Applicant: Sanyo Electric Co Ltd  
 Correspondence Reference Number: 22971  
 731 Confirmation Number: TC419678  
 Date of Original Email: 09/08/2005

Subject: Request for additional information

Figure A1. Channel Power CDMA

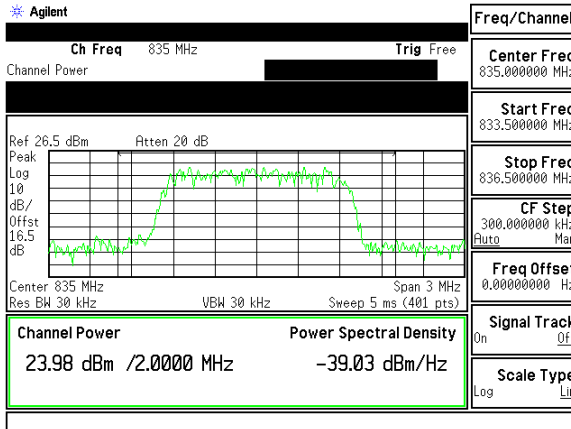
Regarding your answer to question 2 the answer did not seem to address the question. Please provide side by side comparison of "channel power" and 0 span peak power measurement.

Please see below side by side comparison of "channel power" and 0 span peak power measurements:
